Docket Item #6
BAR CASE #2008-0048

BAR Meeting
May 28, 2008

ISSUE: Alterations
APPLICANT: Eric E. Tolbert
LOCATION: 307 N. Patrick Street
ZONE: RB Residential

Figure 1. 307 N. Patrick Street.

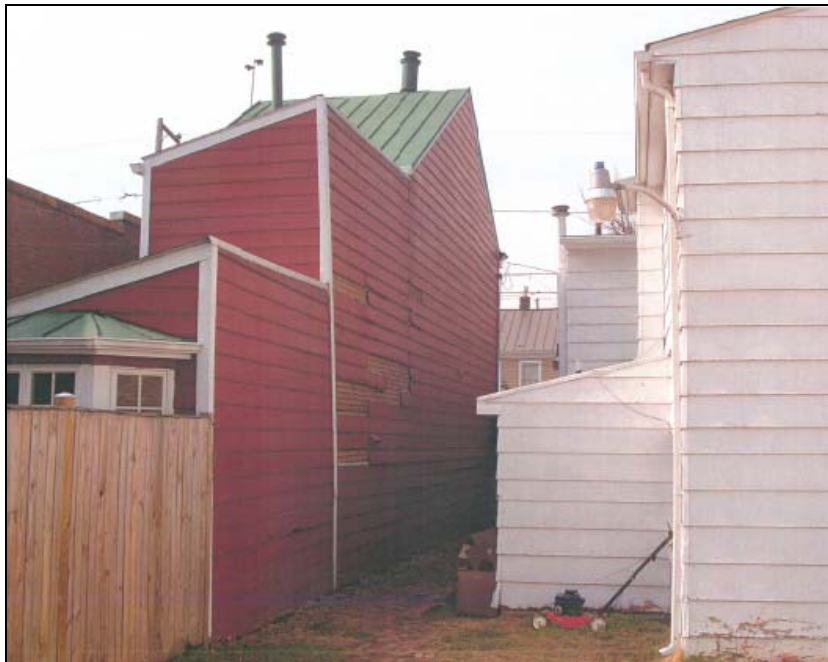
The applicant is requesting approval of a Certificate of Appropriateness to replace the existing rotting and missing masonite siding on the north elevation with a smooth finish, beaded, 7” exposure Hardiplank. Underneath the masonite is a brick-tec like product, which will be retained. There does not appear to be any historic wood fabric underneath the brick-tec. At this time, the applicant is only requesting approval for replacement material on the north elevation. This elevation has views from the primary public right-of-way of North Patrick Street.

The *Design Guidelines* note that siding is one of the principal character defining elements of a building and that brick and wood are the predominant exterior wall materials in the historic districts. It is a central tenet of historic preservation that original historic materials should be retained and repaired rather than replaced. The *Guidelines* recommend an informed and careful analysis of the existing condition be undertaken before determining to replace and encourage repair and retention of historic materials whenever possible. As stated previously, in the area where the applicant is wishing to use Hardiplank, Staff did not see any historic materials.

Staff is aware that the Board has approved Hardiplank siding in the Parker-Gray district in a number of cases over the past six or so years. The Board has considered each case on its own merits within the context of the *Design Guidelines* and the above policy. In most cases where Hardiplank was approved by the Board, the replacement was occurring on secondary elevations (not the front façade), in less visible areas, or in areas that had limited access for maintenance. In Staff's opinion, this application merits approval since the Hardiplank will be used only on the north side elevation rather than on the primary facade, and because no historic materials were found beneath the existing synthetic sidings, and the area has limited access for maintenance.

1. That the nails not show in the installation of the siding; and
2. That smooth siding be installed.
